Subject:Fwd: FW: AHMD_FOOD COURT OUTLETS_DHABAAttachments:PNG LINE BOQ - Ahmedabad Airport TFS.xlsx

Subject: FW: FW: AHMD_FOOD COURT OUTLETS_DHABA

Subject: AHMD FOOD COURT OUTLETS RENDER

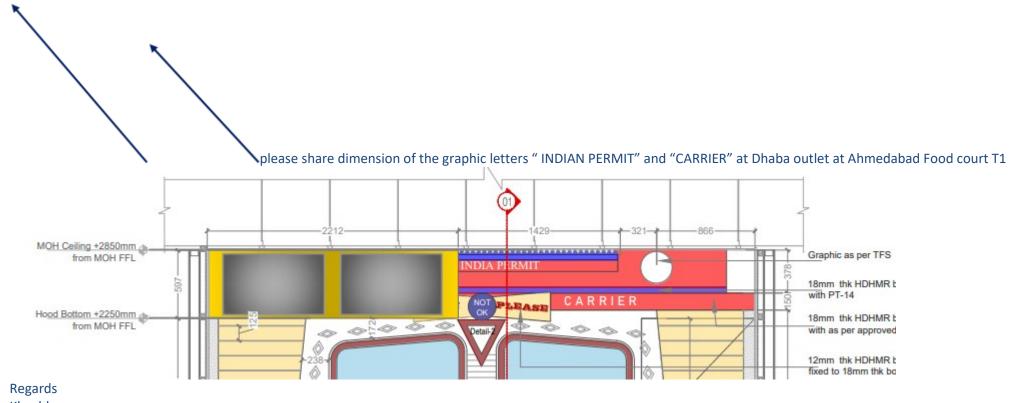
Please find the attached text height as required.
